DEVELOPMENT ASSESSMENT REPORT	
Application No.	REV/2021/0002
Address	8 Richards Avenue MARRICKVILLE NSW 2204
Proposal	S8.2 review Determination No. 2020/0489 dated 13 October 2020 to carry out alterations and additions to a dwelling house
Date of Lodgement	03 February 2021
Applicant	Burrell Threlfo Pagan Pty Ltd
Owner	Mr Eddy Younan Mrs Jocelyn Younan
Number of Submissions	Nil
Value of works	\$80,000.00
Reason for determination at Planning Panel	Clause 4.6 variation exceeds 10% Previous Panel determination
Main Issues	FSR Bulk & Scale Character
Recommendation	Refusal
Attachment A	Reasons for refusal
Attachment B	Plans of proposed development
Attachment C	Clause 4.6 Exception to Development Standards
Attachment D	DA/2020/0489 IWLPP Report and Recommendation
Attachment E	Draft Conditions (if panel approves)

The application has been lodged seeking a review under Section 8.2 of the Environmental Planning and Assessment Act 1979 of the refusal of DA/2020/0489 for alterations and additions to a dwelling house.

PROPOSED ATTIC FLOOR PLAN

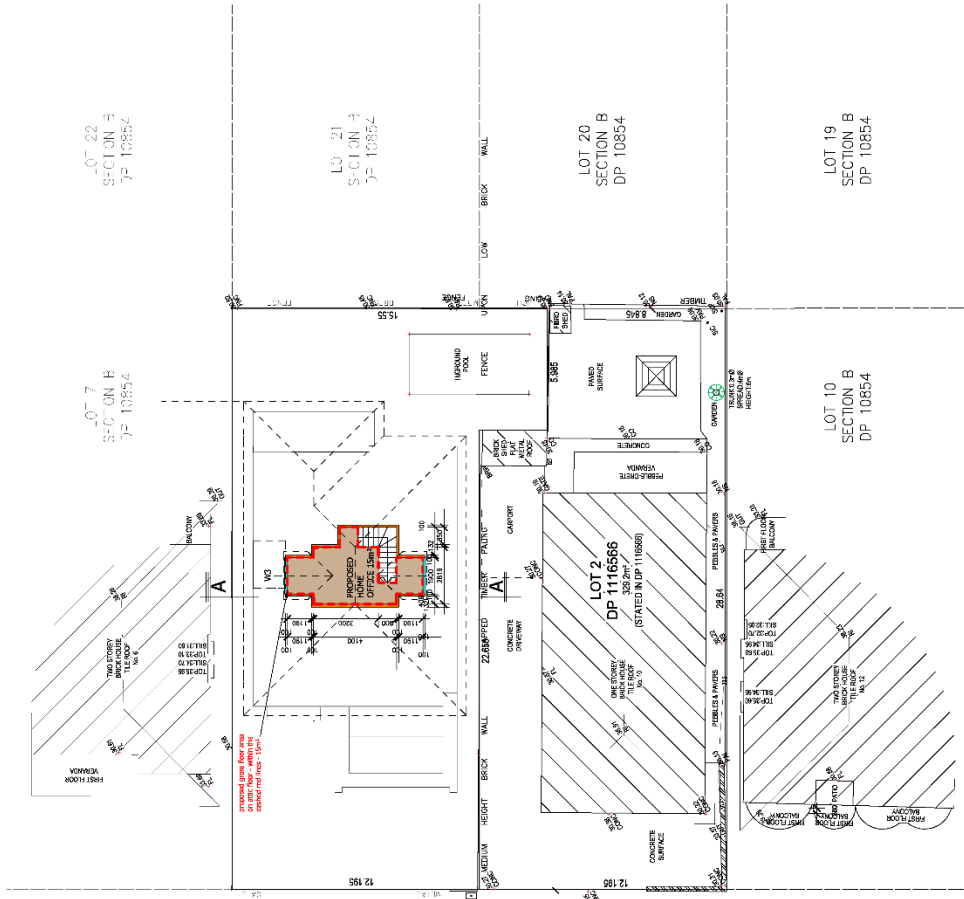
Control C40 allows the use of dormers in contemporary buildings to be determined on merit. Given their lateral expanse and direct presentation to the street, the proposed dormers are considered to dominate the roof plane and appear as a full third storey, contrary to Control C41. In accordance with Control C43, it is considered that dormer windows do not suit the architectural style of the building as they do not utilise existing roof space and create a complex roof form which is not sympathetic to the existing dwelling. Roof forms are major generators of building form and in this case the removal of the existing roof form and replacement with the proposed design is considered detrimental to the streetscape. Furthermore, contrary to C51, the use of dormers is considered inconsistent with the other existing roof forms in the street. Therefore, it is considered the proposal does not enhance the character and quality of the streetscape and fails to satisfy the relevant objective. The material submitted with the

The proposal includes two side-facing dormer windows to service the third storey. Control C40 allows the use of dormers in contemporary buildings to be determined on merit. Given their lateral expanse and direct presentation to the street, the proposed dormers are considered to dominate the roof plane and appear as a full third storey, contrary to Control C41. In accordance with Control C43, it is considered that dormer windows do not suit the architectural style of the building as they do not utilise existing roof space and create a complex roof form which is not sympathetic to the existing dwelling. Furthermore, contrary to C51, the use of dormers is considered inconsistent with the other existing roof forms in the street.

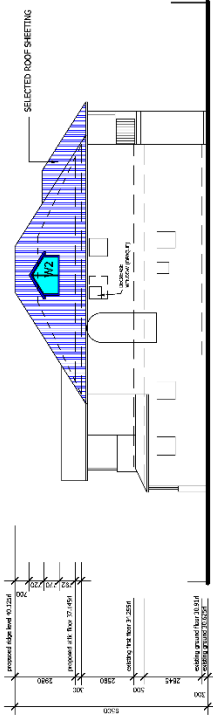
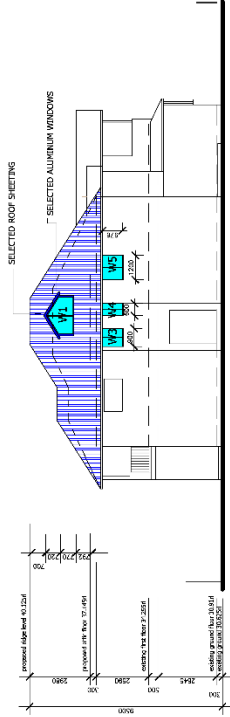
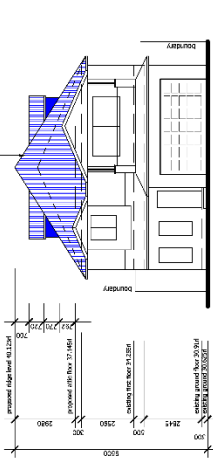
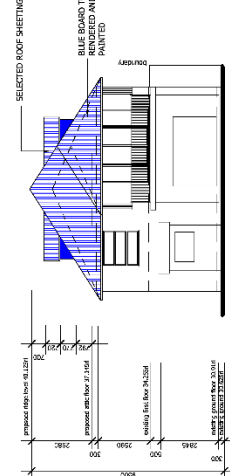
The plans provided with the development application fail to illustrate the adjoining site context adequately in elevation with only elevations of the subject house provided.

The height of the new roof form/ 3rd floor is considerably taller than nearby development and results in a building which is considerably large and tall and at odds with adjoining development. Specifically, the proposal is 1.845 metres taller than the adjoining 2 storey dwelling house at 6 Richards Avenue and is 4.65 metres taller than the adjoining single storey dwelling house at 10 Richards Avenue, thereby failing to provide an adequate transition between adjoining development.

Furthermore, the applicant is seeking to provide corrugated roof sheeting for the new portion of the roof which is at odds with the 2 smaller tiled gabled roofs on the dwelling which are to
